Change in the Print on the Product Cover of the FX3S Main Units

This technical bulletin informs you of a change in the print on the product cover of the FX3S main units due to the standardization of LOT labels.

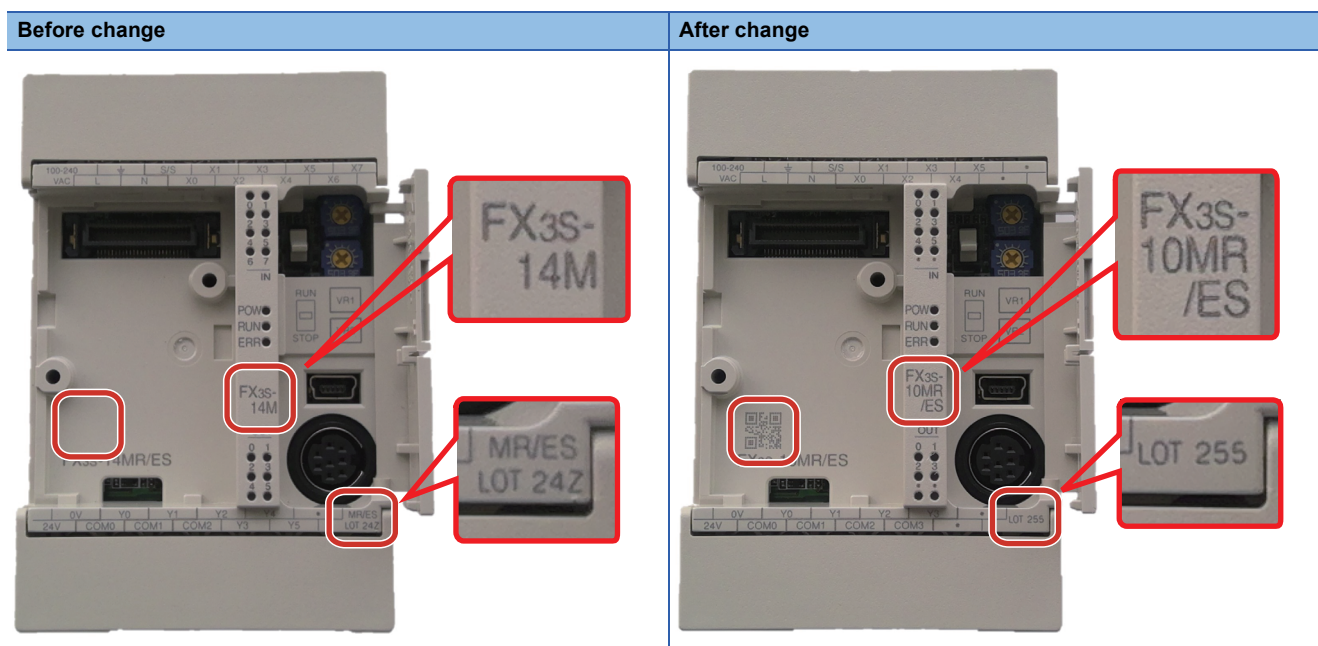
- Addition of the two-dimensional code for the model name to the top cover mounting area
- Change of the model name from the abbreviation to the full name
- Removal of the model name from above the lot number

The changes will be applied to products manufactured from May 2026 onwards.
